# Conceptual Review Agenda

Schedule for 07/14/14 to 07/14/14

**Re:** 2590 Midpoint Dr - Light Industrial

**Description of project:** This is a request to build a commercial kitchen at 2590 Midpoint Drive (Parcel # 87202-06-018). The proposed one-story building will be 6,000-8,000 square feet with a small parking lot and delivery truck turnaround. The parcel is located in the Industrial (I) zone district. This project will be subject to Administrative (Type I) review.

2 CONCEPTUAL PLAN  
1" = 10'-0"

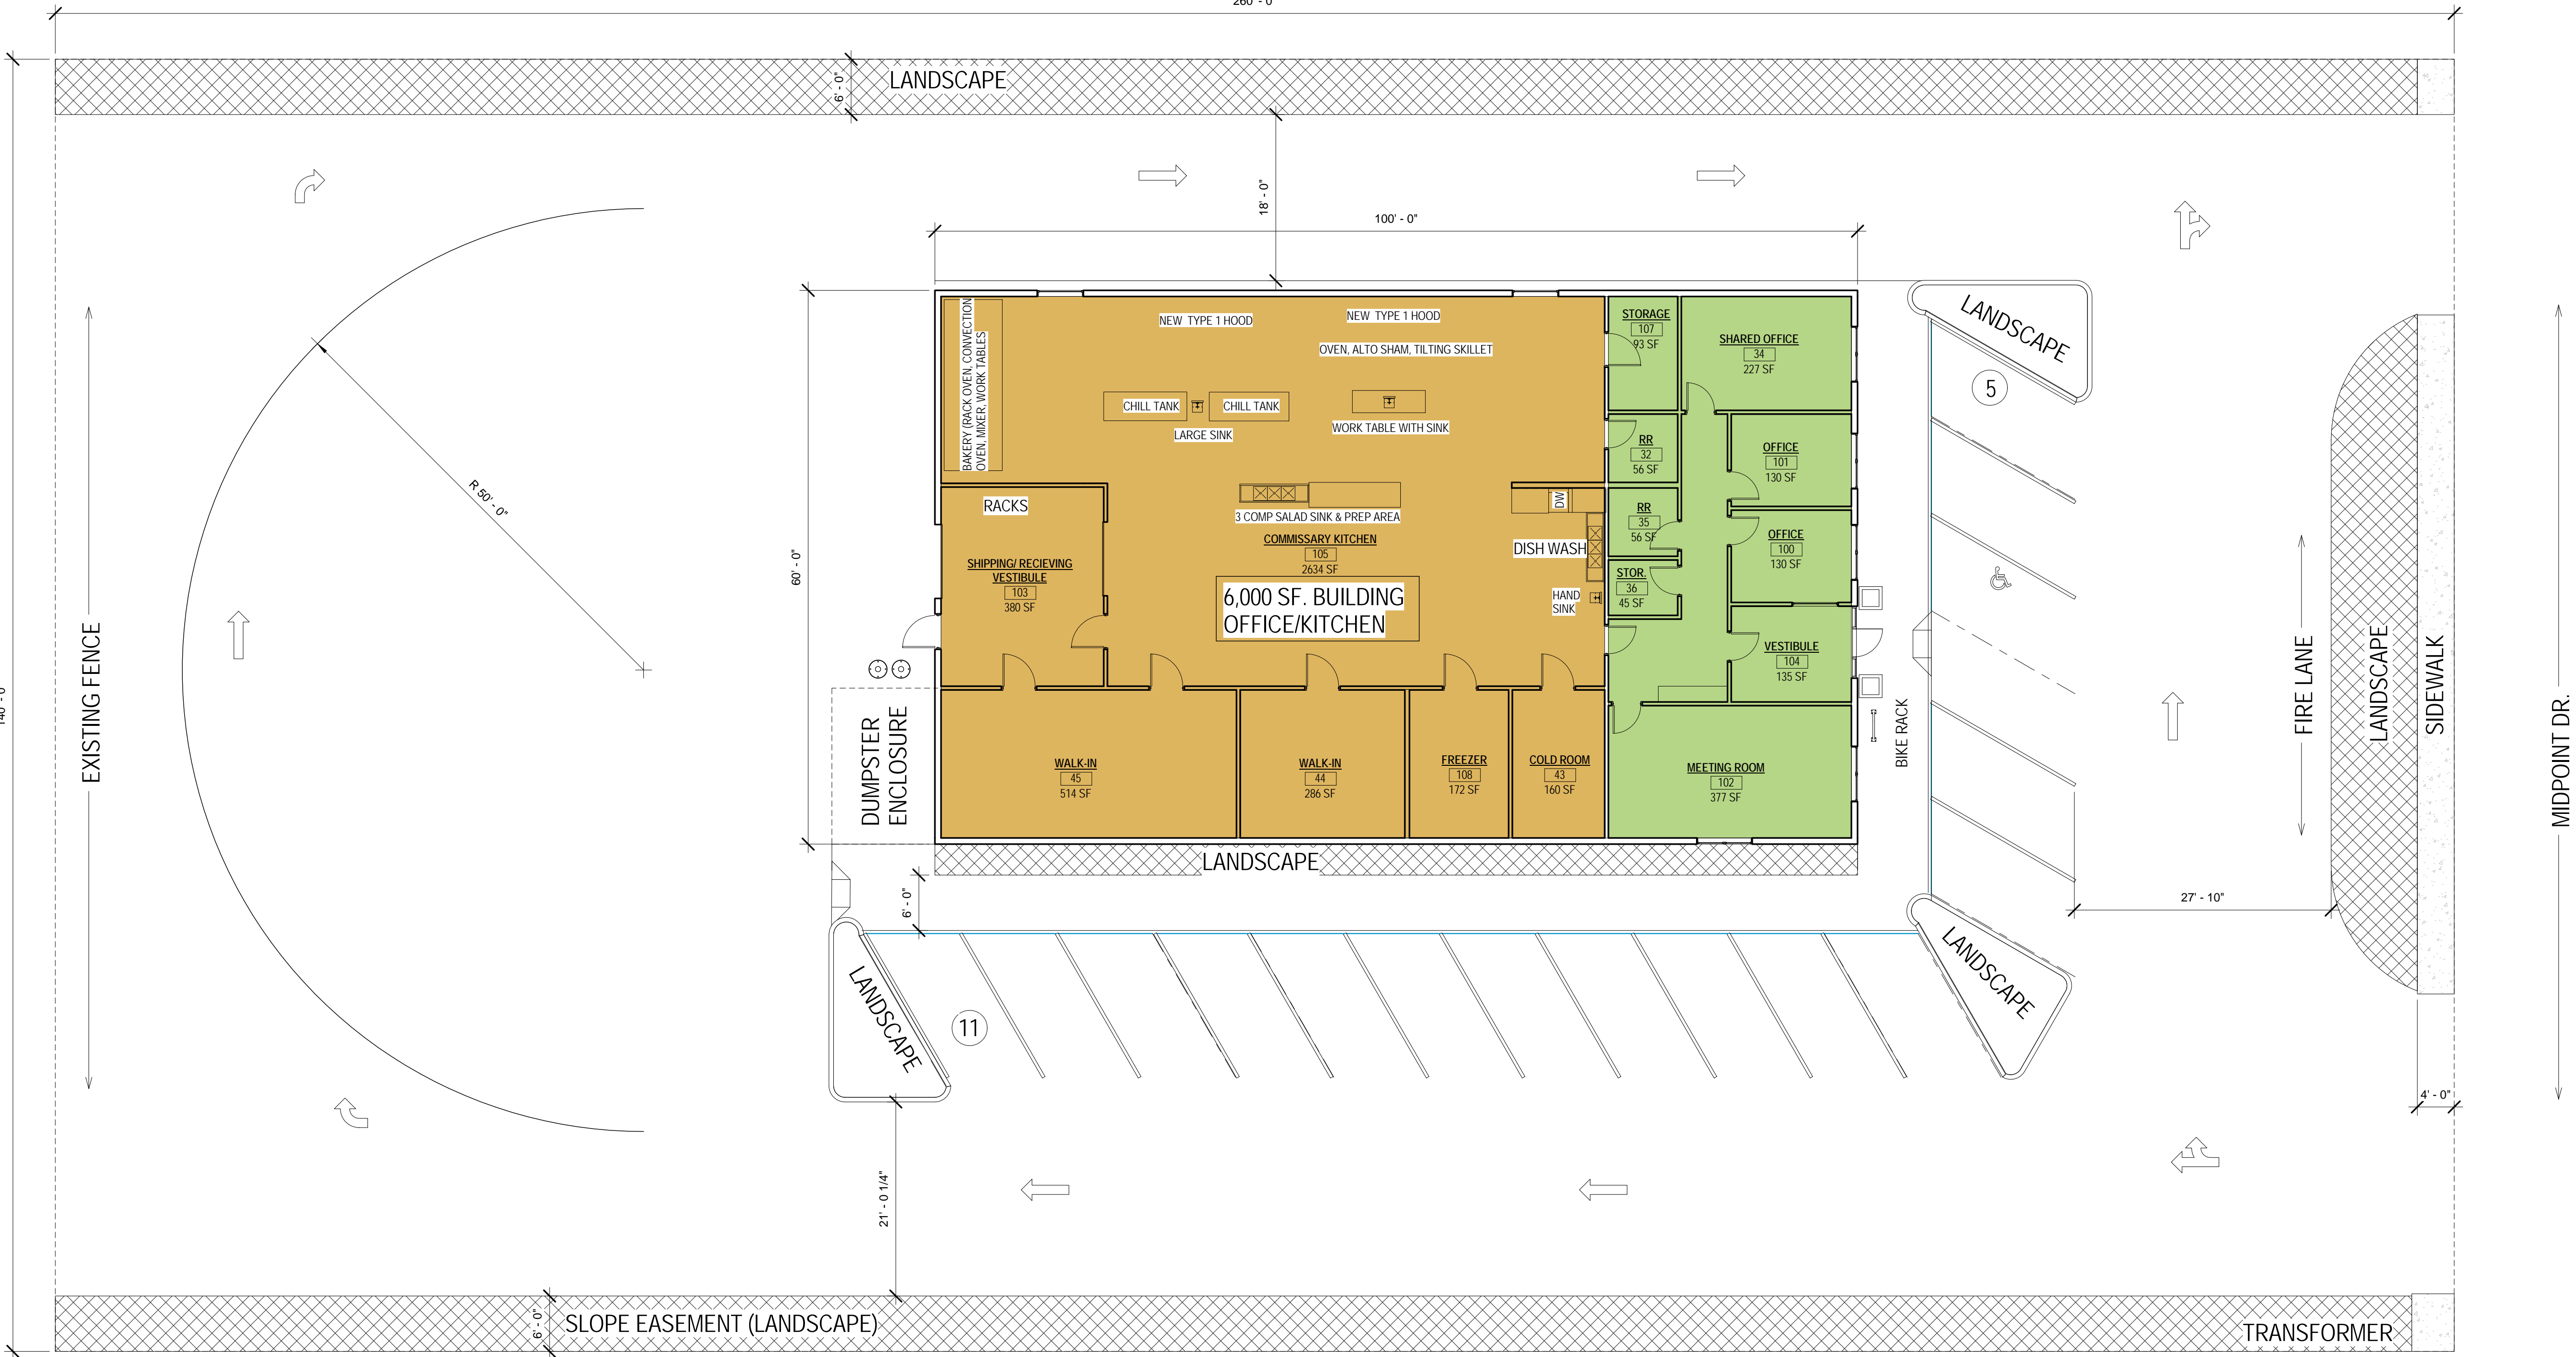
2. The depth of the front landscape area must be a minimum of 10 feet. A minimum 5 foot deep landscape setback is required along the length of the rear lot line. 6% of the interior of the parking lot, including the driveways and other vehicular use areas, needs to be in the form of landscape islands. Three such islands are shown, but more are probably needed to comply.

3. Consider changing the front parking stalls to 90 degree stalls unless the two driveways are going to clearly be labeled "entrance only" and "exit only".

4. Foundation plantings in beds at least 5 feet wide and along 50% of a building wall are required along building walls that are in high-use or high-visibility areas. This will apply along the front wall and at least along the front portion of the side walls.

1. We will need a little more information on the use of the facility, and anticipated traffic volumes to determine whether a Traffic Impact Study (TIS) is needed. How will the kitchen be used? By Whom? How many vehicles per day? etc. Section 4.2.3.D of the LCUASS defines when a TIS is not required and this development will need to provide information on whether they are under this threshold or not.
2. The street frontage on Midpoint will need to be built to a minor collector standard. This includes an 8 ft parkway and 5 ft detached sidewalk, much like what was built on the parcel immediately to the northwest.
3. Two access point are shown on the plan. The preference is for a parcel to have only one access point. The applicant will need to provide information on whether the proposed two access points meet the LCUASS access spacing requirements (See Table 7-3).

6. Midpoint is considered a Collector Roadway. Access spacing shall be in accordance with standards – which mean access points (driveways) need to align or meet separation distances.

1. A minimum 5' landscaped area is required along the rear lot line, and the front parking and drive aisles require a minimum setback of 10' from the front lot line.
2. As you begin preparing landscaping details, please consider the following requirements:
